RE: Area Permit

OS6273 Chaparral Area Permit

Re: Area Permit – Pre-Existing Injection Wells
North Burbank Unit- CO2 Phase I
Location: SE/4 Sec 10, S/2 Sec 11, SW/4 Sec 12, all of Section 14
and the N/2 of Section 23, all in Township 27N, Range 5E
Osage County, Oklahoma
Permit No. 06S124P6273

N.B.U. 23W28

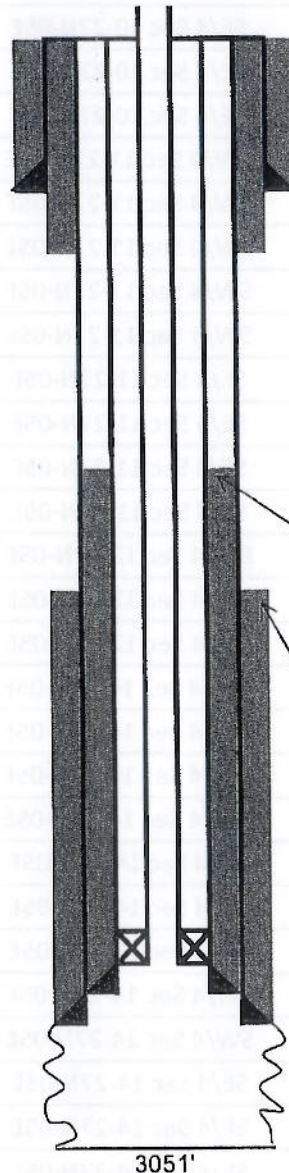
These wells were originally completed with 4-1/2" casing, but during the past several years 3-1/2" liners were installed. At the same time, cement was also placed behind the original 4-1/2" casing from the surface to a depth of approximately 325' (see Attachment B). All such well work was approved by the EPA.

In order for these wells to now meet the requirements of the Permit the 3-1/2" and 4-1/2" casing will need to be perforated and cement placed behind the 4-1/2" casing from a depth of 500' up to approximately 325' (Special Permit condition I.A.3). This would not only be difficult, but the end result could never be assured. Additionally, such procedure would, of course, weaken the integrity of the 3-1/2" casing, increasing the possibility of MIT failure and providing a potential avenue for CO2 migration at a very shallow depth.

Furthermore, to add the existing injection wells to the Permit will also require submission of cementing records and a bond log or temperature survey (Special Permit Condition I.A.4). As mentioned above, the subject wells were drilled and completed several years ago by a former operator. Because of their age and ownership history the well records are not complete, however, we have been able to locate cementing reports, which we believe clearly demonstrates that sufficient cement was pumped to achieve a minimum of 1000' of coverage above the producing zone. In some cases, the old well reports state the top of cement as high as 1700' above the Burbank. Attached are representative cementing records, cementing tickets, well reports, and other supporting documents.

Arnold and I discussed the request as put forth in Larry's letter of November 8, 2012. We are in agreement that it is prudent not to jeopardize the integrity of the 3.5" liner. While we will offer that position to Phil, I cannot promise he will agree. Phil is out until Monday the 26th. If he is in agreement, Arnold proposes that we can remedy the situation by doing a non substantial revision to the General Permit Part I A. 3. to read:

3. For those existing wells without surface casing or whose surface casing does *not* extend at least 50 feet below the USDW, the outermost casing(s) must be cemented at least 50' below the USDW to surface.

If we are able affect those changes, it would appear to me that the example well would be constructed sufficiently to meet the GP's requirements.
